UNLESS OTHERWISE SPECIFIED TOLERANCES		东莞市汉博电子科技有限公司 DONGGUAN HANBO TECHNOLOGY CO., LTD			
DECIMALS: X ±0.30 X.X ±0.20 X.XX ±0.10		TITLE TYPE C 母座 11.95 前插后贴 DWN xiong PART NO. MC-261 CHKD lee SCALE:1:1 UNIT: mm APVD wang SIZE: A4 SHEET:10F 1 REV: A4			
ANGLES: X ±2° X.X ±1°		CUSTOMER COPY

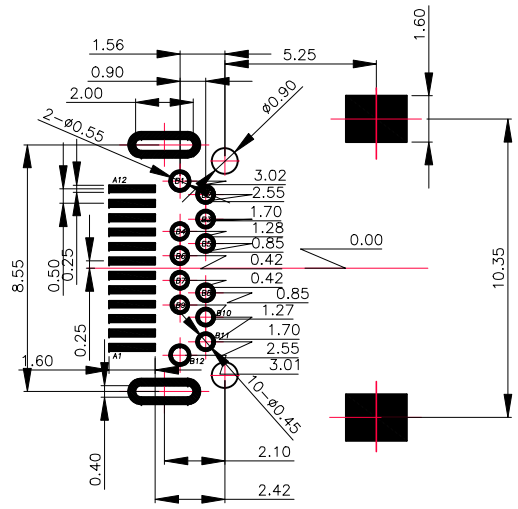
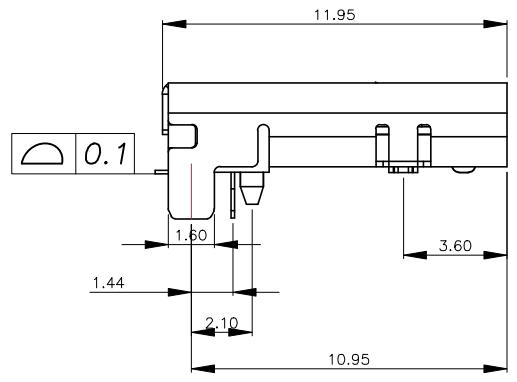
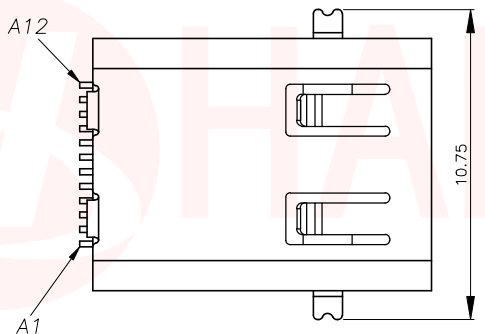
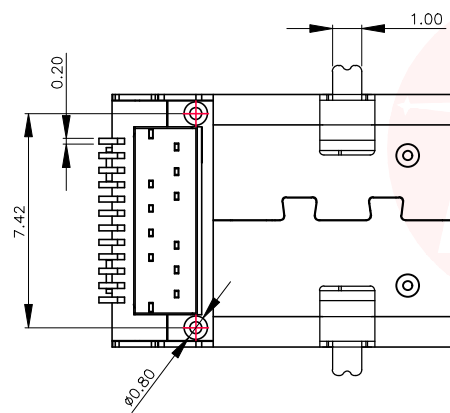
增加外壳脚两边平整度  
管控0.08
